**Alton Coal Development, LLC**

August 26, 2011

Subject: **Mine and Reclamation Plan-Deficiencies Submittal Coal Hollow Project, Kane County, Utah, C/025/0005**

Alton Coal Development, LLC is pleased to provide this submittal addressing the deficiencies requested in Task List 3862, Task that resulted from the drainage control plan submitted June 20, 2011.

IMPOUNDMENT SPILWAY  
DETAIL

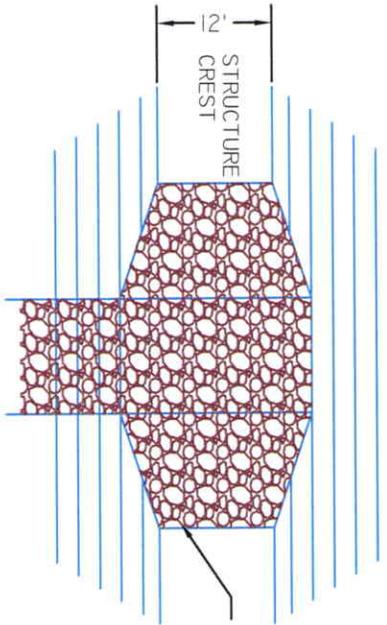
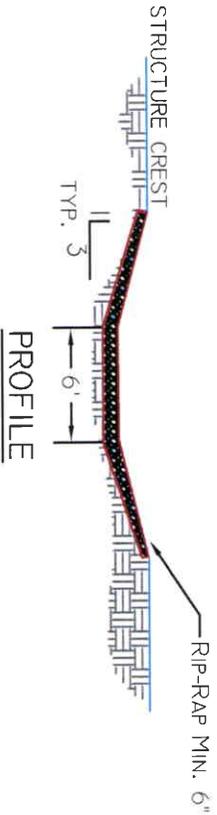
“Open channel spillway details for impoundments 3 and 4 are provided in Drawing 5-32. These spillways are designed for emergencies and are not expected to be used during normal operations.”

“Impoundments 3 and 4 will be constructed with open channel spillways. These spillways are designed to discharge a 6 hour duration, 100 year storm event even though they are not expected to be used.”

“Impoundments 3 and 4 will be constructed with open channel spillways. These spillways are designed to discharge a 24 hour duration, 100 year storm event even though they are not expected to be used during normal operations.”

Impoundments 3 and 4 will be constructed with open channel spillways. These spillways are designed to discharge a 6 hour duration, 100 year storm event even though they are not expected to be used. They will have rip-rap min 6" to minimize erosion and spillway slopes will not exceed 3h:1v. Drawing 5-32 provides the details for the open channel spillways.

Impoundments 3 and 4 will be constructed with open channel spillways. These spillways are designed to discharge a 24 hour duration, 100 year storm event even though they are not expected to be used during normal operations. They will have rip-rap min. 6" to minimize erosion and spillway slopes will not exceed 3h:1v. Drawing 5-32 provides the details for the open channel spillways.
